Hillingdon

Outline Fire Strategy – Rev E

OF-OFS-3671-01-E

Appendix A – Drawing Comments

1 Building 10 - Ground Floor Plan
1 : 200

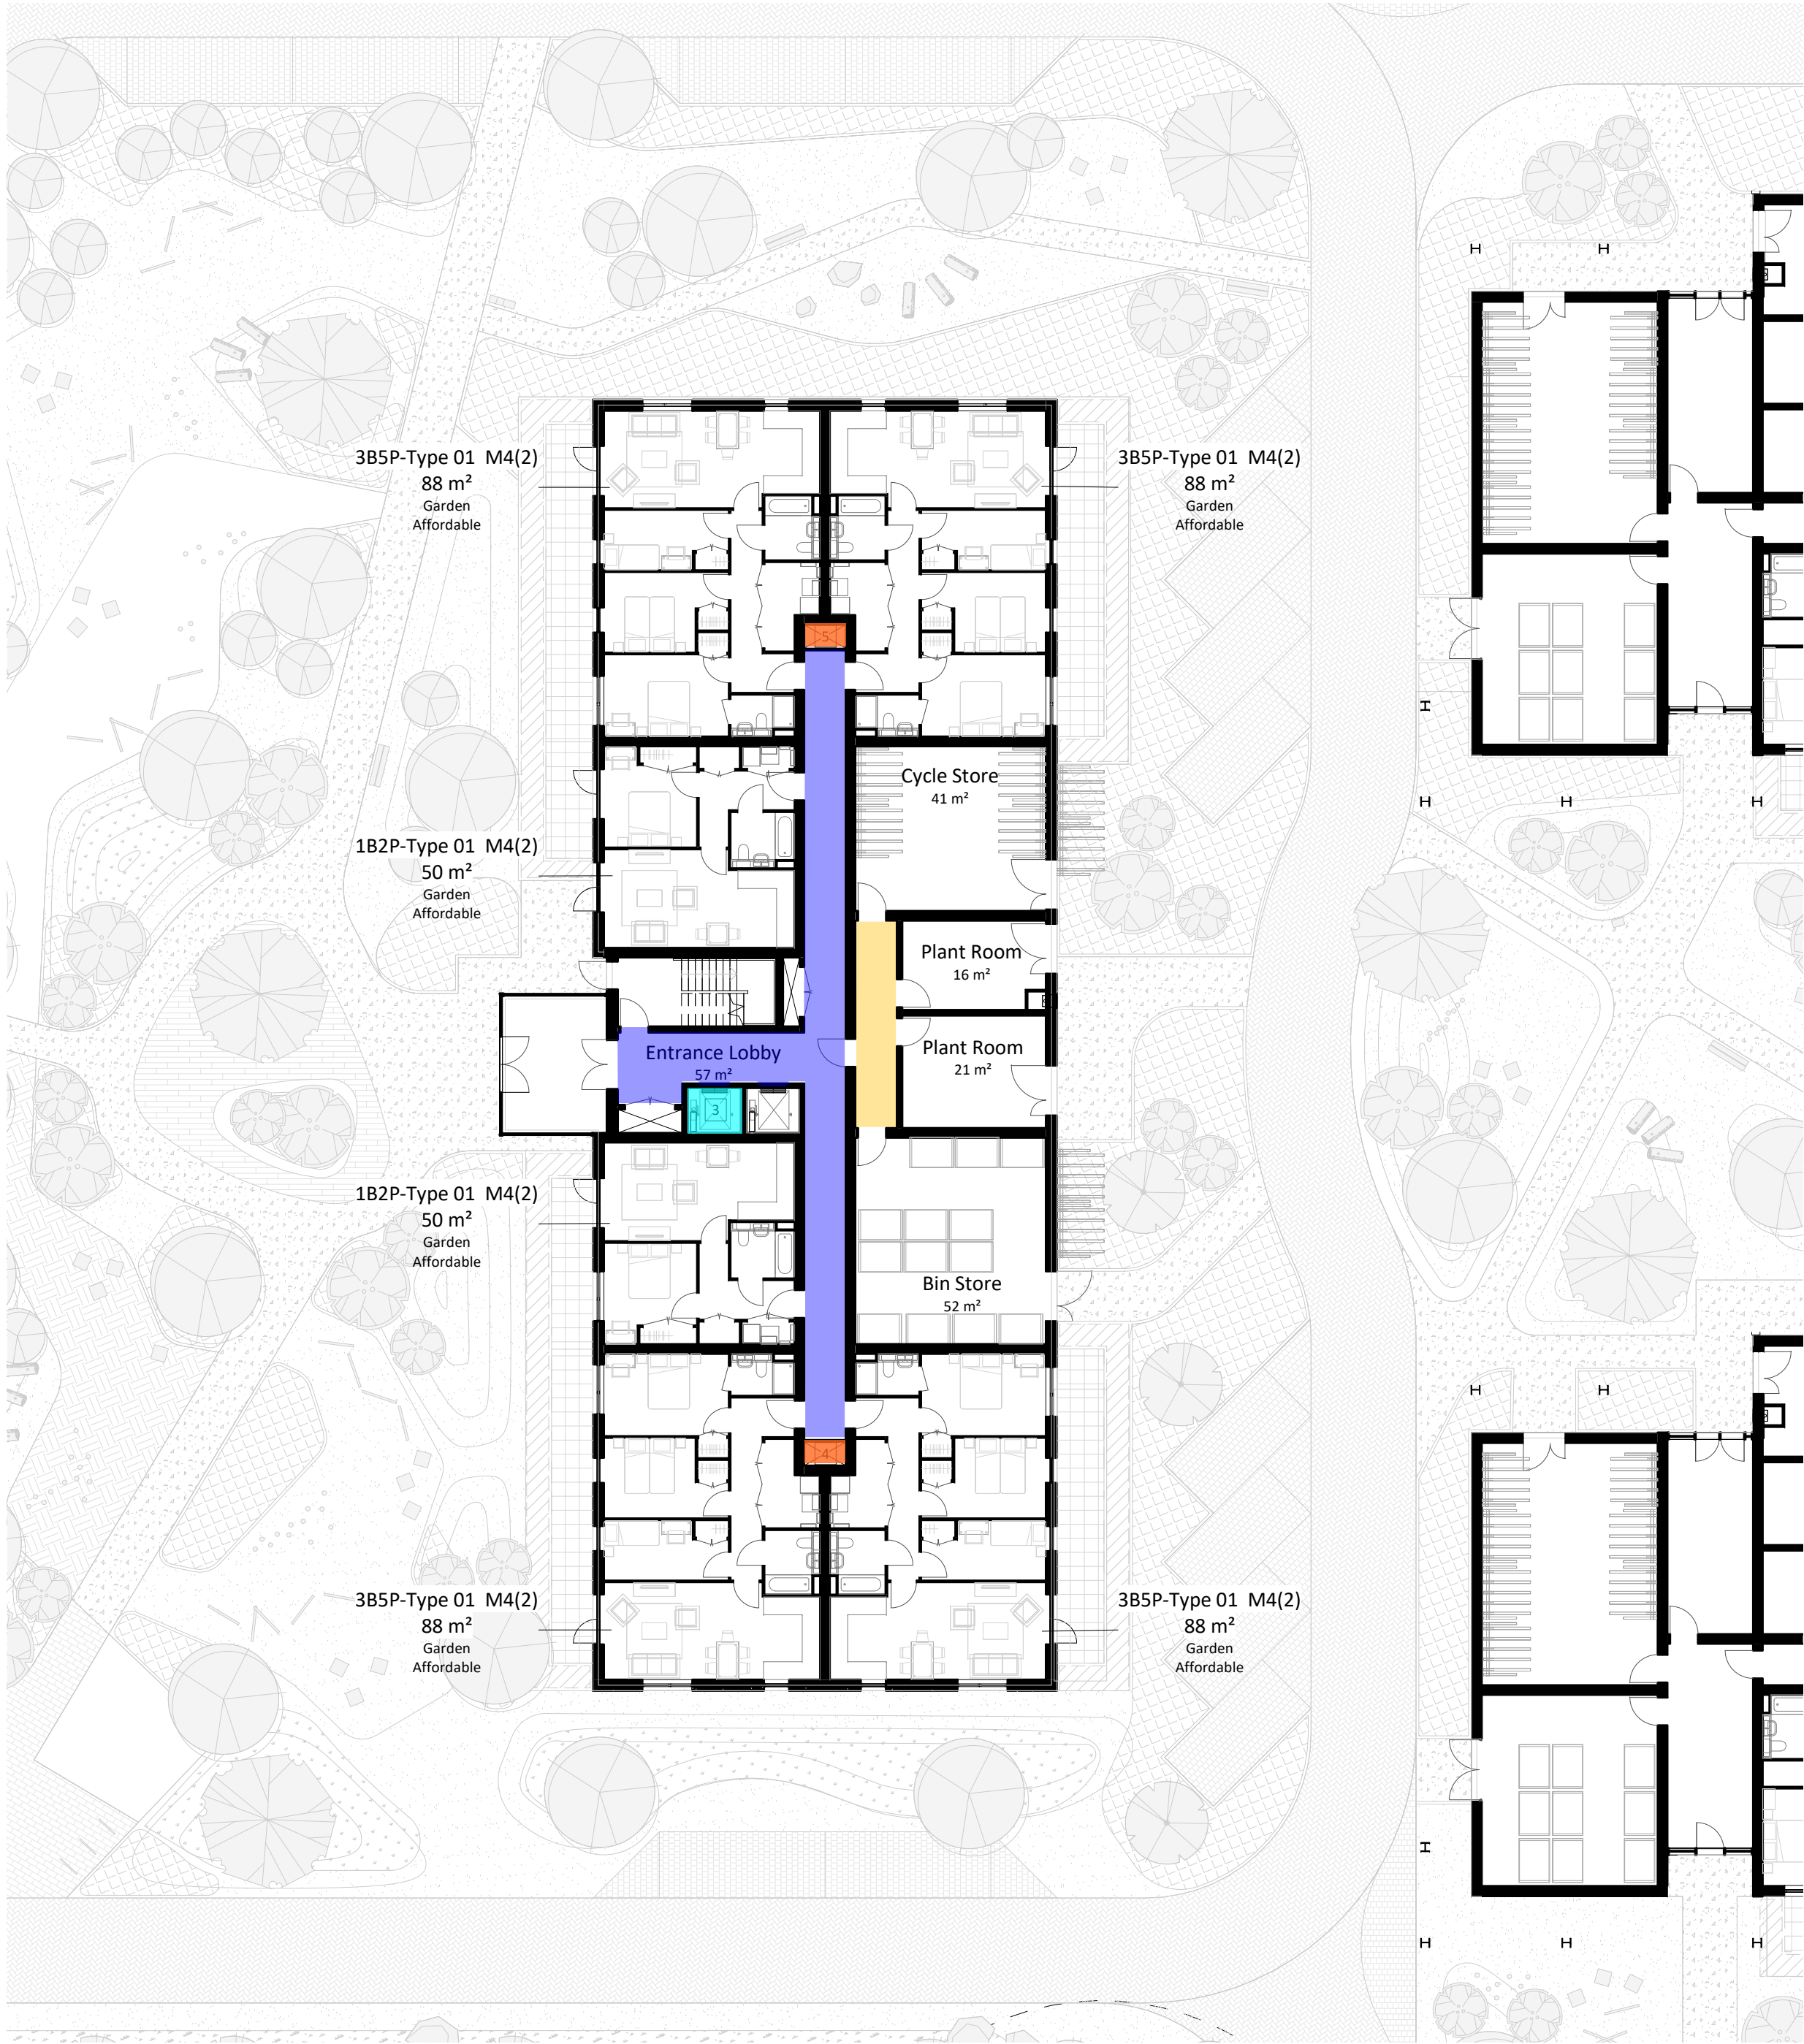
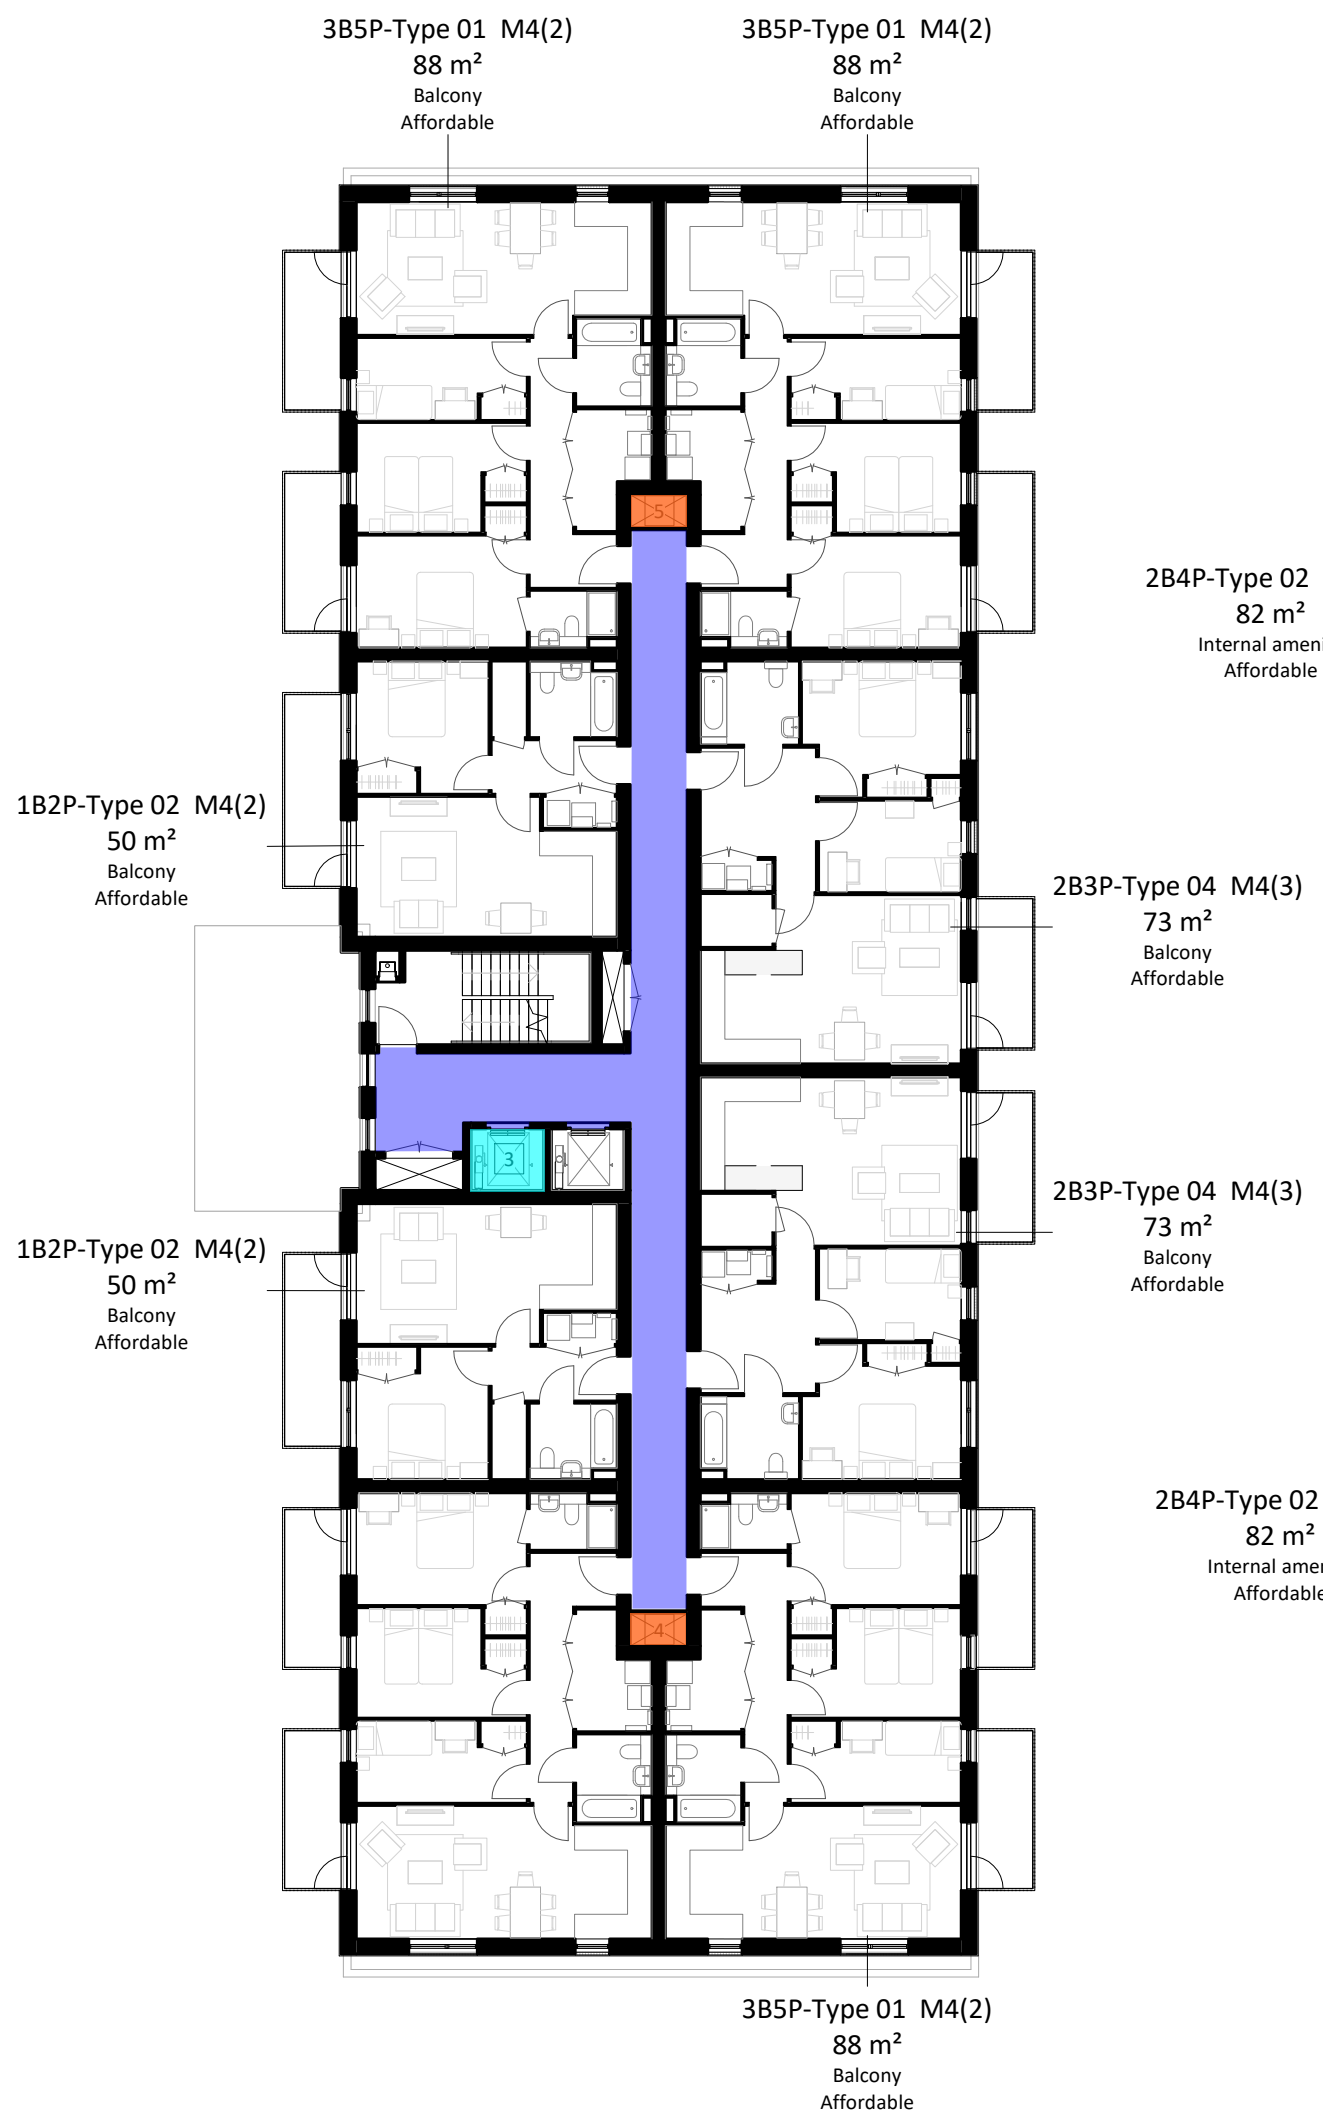
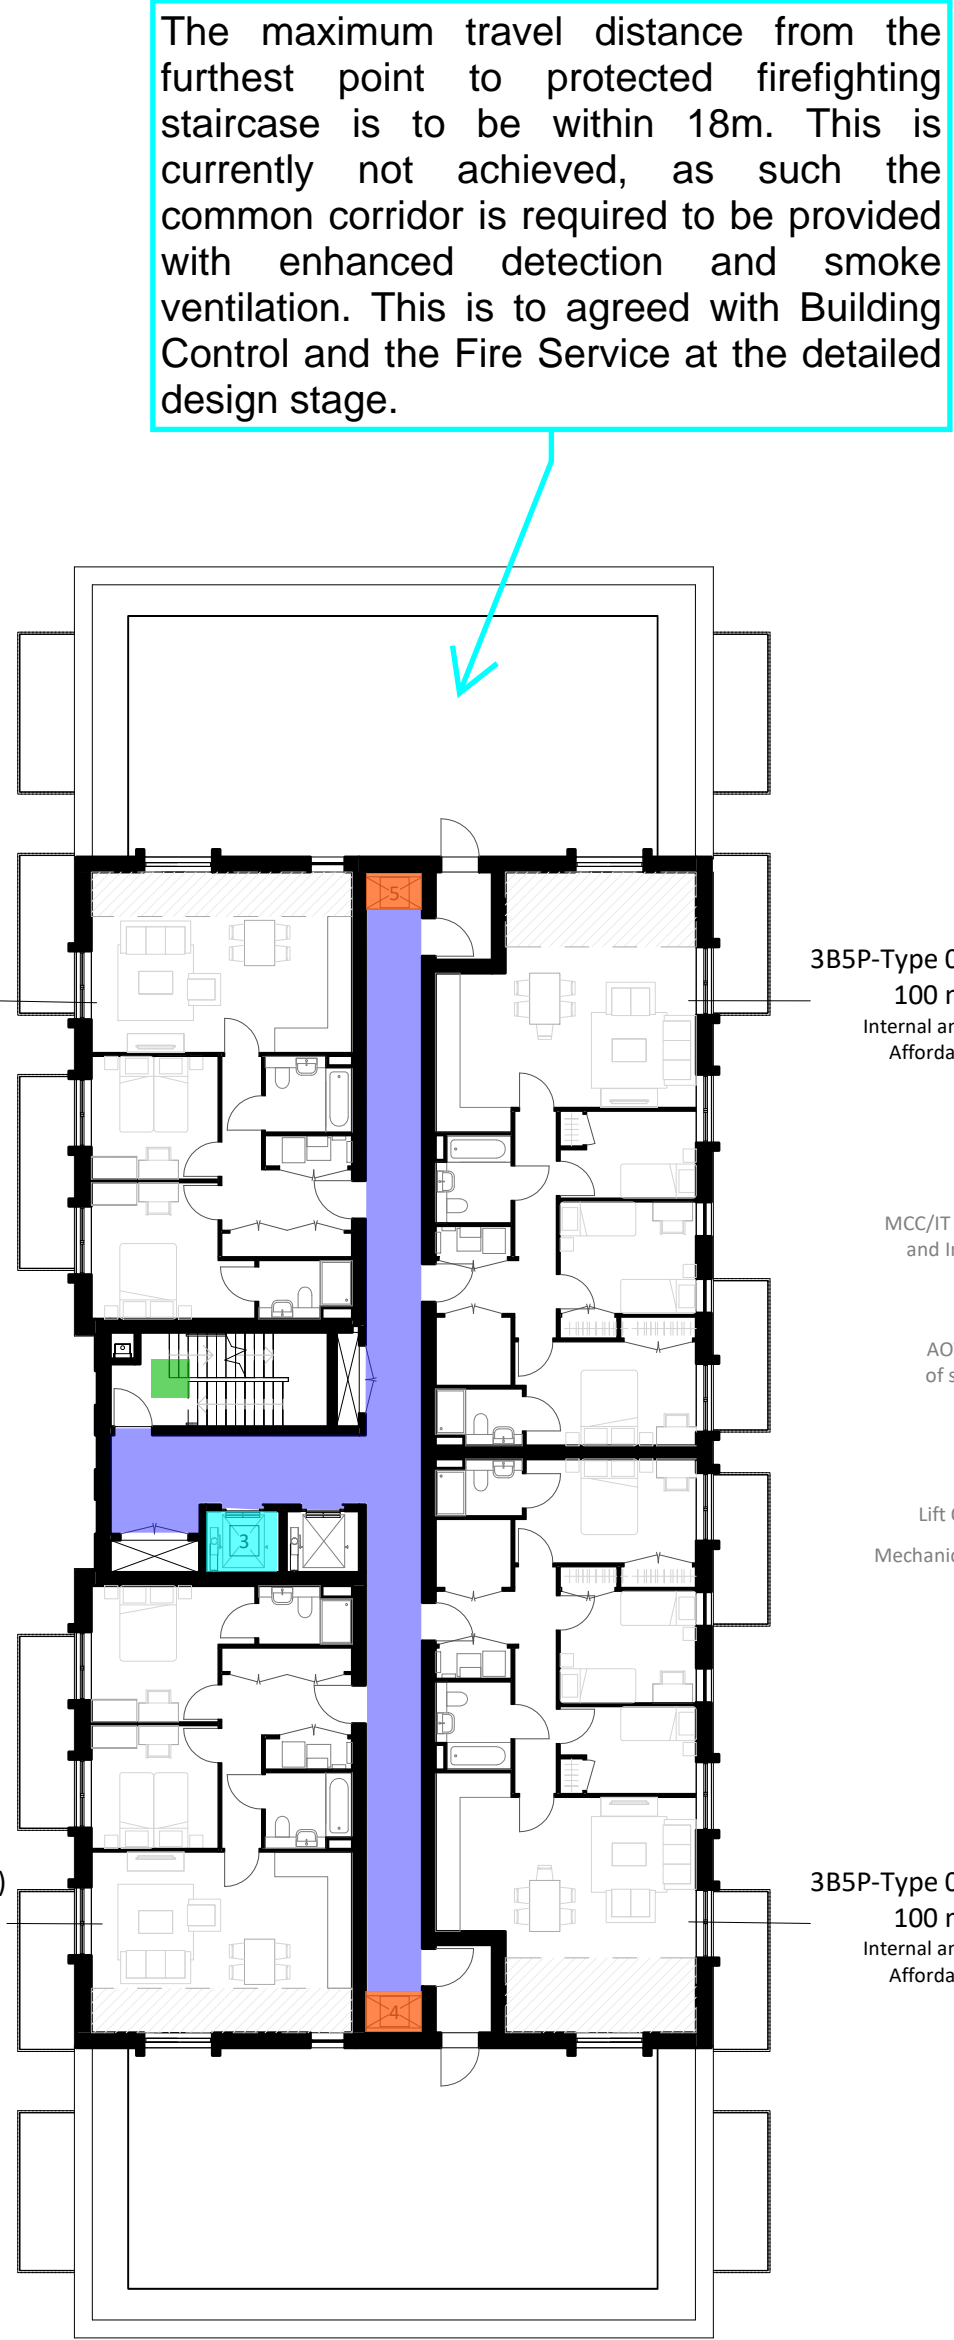
To be noted, if the service riser is to only contain water services or metal ventilation ductwork from the ground floor, it is considered a limited fire hazard. As such, this riser shaft may be located in the staircase lobby.

The cross-corridor doors and the lobby AOV's direct to the external are to be omitted, allowing for 2x 0.8m² mechanical smoke shafts are to be provided at the remote ends of the corridors (one at each end). CFD modelling would be required to justify this deviation. However, considering that the travel distance isn't excessive and that the apartments are not impeding the vertical escape route, it is considered that this proposed solution has limited design risk.
